UNITED STATES PATENT AND TRADEMARK OFFICE

APPLICATION NO.	FILING DATE	FIRST NAMED INVENTOR	ATTORNEY DOCKET NO.	CONFIRMATION NO.
10/531,786	04/18/2005	Martin J. Weinstein	PB0288	3882
22840 7590 09/08/2008 GE HEALTHCARE BIO-SCIENCES CORP. PATENT DEPARTMENT 800 CENTENNIAL AVENUE PISCATAWAY, NJ 08855				
EXAMINER MENON, KRISHNAN S				
ART UNIT 1797		PAPER NUMBER		
MAIL DATE 09/08/2008		DELIVERY MODE PAPER

Office Action Summary

DETAILED ACTION

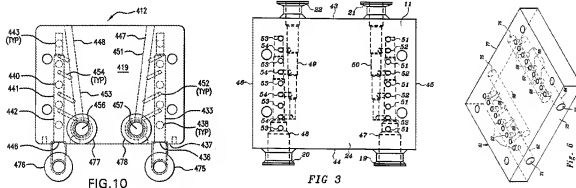
Applicant' figure 10, assumed to be best representing the claims in comparison with figure 5 of Latour and figure 6 of Friedman.

Friedman teaches a filtration housing with an end plate having parallel feed and retentate channels, and filtrate channels, wherein the filtrate channels have transverse portions, the transverse portions forming acute angles with the upper surface of the end plate. See fig 6 above, as well as fig 4 of the reference. Particularly, this reference teaches:

The teaching of the reference differs from the claims in the ‘acute’ orientation of the transverse filtrate channels with respect to an upper surface of the first end plate. Friedman teaches the transverse filtrate channels as being at an acute angle with a face of the end plate, but this does not appear to be the “upper surface” as claimed. The [first] plate (11) of Latour is also a central plate (communication to the filter cassettes from both major surfaces), whereas the applicant depicts it as an end plate (communication to the cassettes only from one major surface). Latour refers to Friedman and teaches his design as an improvement over that of Friedman, who has the plate with inlet and outlet channels at an end. However, the “acute” orientation of the transverse filtrate channel is only an obvious design change in shape and/or orientation, which one of ordinary skill in the art is capable of; and are not patentable unless can be shown otherwise. Changes of size, shape, etc without special functional significance are not patentable. *Research Corp. v. Nasco Industries, Inc.*, 501 F.2d 358; 182 USPQ 449 (CA 7), cert. denied 184 USPQ 193; 43 USLW 3359 (1974). Applicant

has not demonstrated any criticality of having the acute angles in the transverse filtrate channels to overcome a prima facie case of obviousness.
